INSTRUCTION TO SERVICE

IT61290		March 10 2025
SECTION:	290-ELECTRICAL SCHEMATICS 292-ELECTRICAL HARNESSES 296-ELECTRICAL DECALS	
SUBJECT:	Add connection between Node 04 & 24V.	
ISSUE:	<p>This was originally required for the Depot charging to communicate with the modem and wake up the bus when charging could be started. When XHE's came along, Freeze protection was added and made use of this existing alive module.</p> <p>With the implementation of the EVCC charging system, there was no longer a requirement to keep Node 4 alive. Unfortunately, there was nothing directly linking the Freeze protection to this requirement on the schematic. And thus, we put Node 4 back to the normal PLC awake signal.</p>	
SUMMARY:	Create a connection between Node 04 and rear panel 24V

ITS61290

REAR PANEL

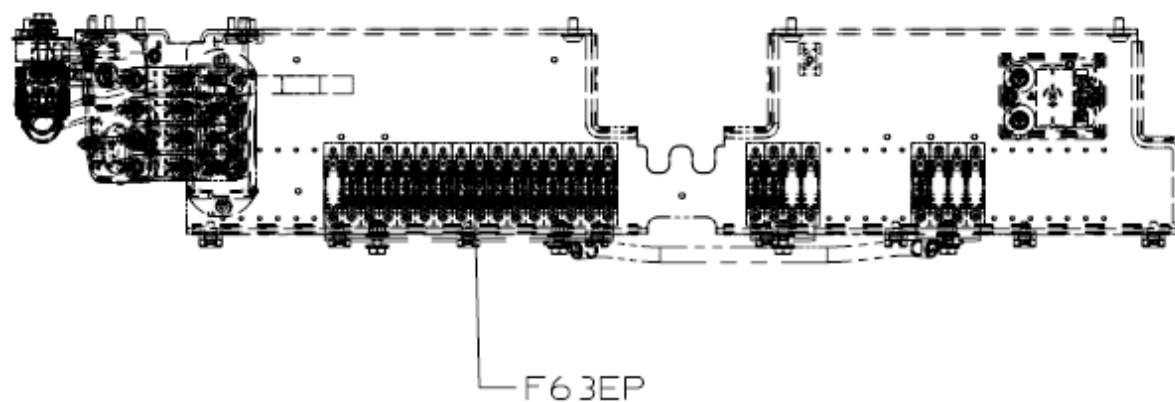
1. Locate HRNS-RH Options RR from INSTL-HRNS RH Option RR, REF 292-XXXXC line item 54.
2. Locate existing “NODE 04-J1-3” in Exit Door Panel. Unplug and cap wire 54PN04K using Item 2.
3. Locate “F63EP” at the Rear Panel. Using supplied jumper (Item 1):
 - a. Load jumper end “F63EP-2” into Cavity 2 of F63EP in the rear panel.
 - b. Route and connect the other end of the jumper to cavity 3 of “NODE 4-J1” in the exit door panel.
4. Secure the harnessing along the existing harness routing paths.
